## **Radcliff Elementary**

## Project Closeout Update August 5, 2016

## Floor Tile Moisture Mitigation

Image 2

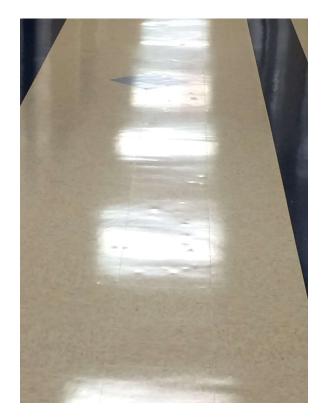
Debris and residue below the floor tile has telegraphed through the newly installed floor tile. The field color in the corridors will be replaced.
